PLANNING, ZONING, & BUILDING DEPARTMENT
PZ&B Staff Combination Memorandum: Architectural Commission and Town Council

SUBJECT: ARC-24-0082 (ZON-24-0045) 740 HI MOUNT ROAD (COMBO)

MEETING: OCTOBER 23, 2024, ARCOM
NOVEMBER 13, 2024, TC

New second floor window

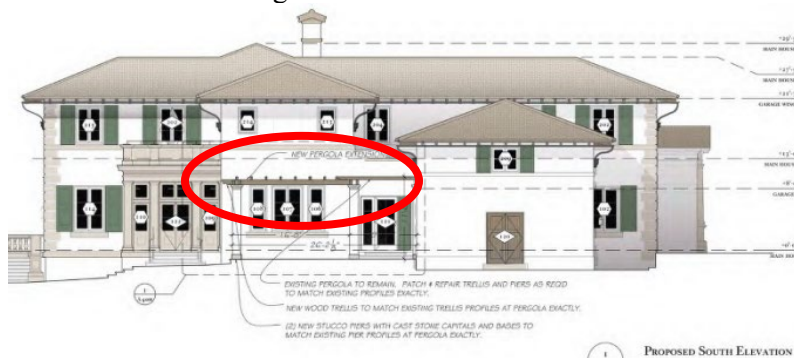
The subject property is located on the west side of Hi Mount Road along the intracoastal waterway just south of Country Club Road. The site features a well-designed Mediterranean Revival style single family home constructed in the late 1990's. The new owner would like to make minor modifications to the property. This includes the addition of a paired casement window on the second floor of the garage with lite pattern to match others and not visible from a public ROW. The second change is the addition/expansion of an open pergola consisting of cast stone piers with a base and capital supporting a cypress wood trellis on the west elevation to match the perpendicular pergola with the same architectural elements running north/south on the west elevation.

Existing/Proposed west elevation as visible from Lake Trail ROW.

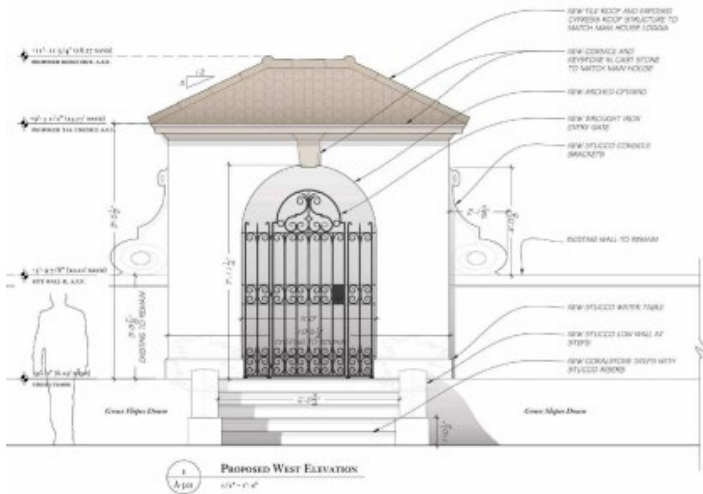
The final and most significant alteration is the reconstruction and reconfiguration of the existing entry pavilion along the west side of the property along the Lake Trail. Due to loss of over 50% of this element a variance is required to build back in the same footprint.

The west elevation is visible from the Lake Trail and now offers an enhanced design with a wrought iron entry gate. Passerbys will be able to get a glimpse through this entry feature to the fountain area versus the current utilitarian structure.
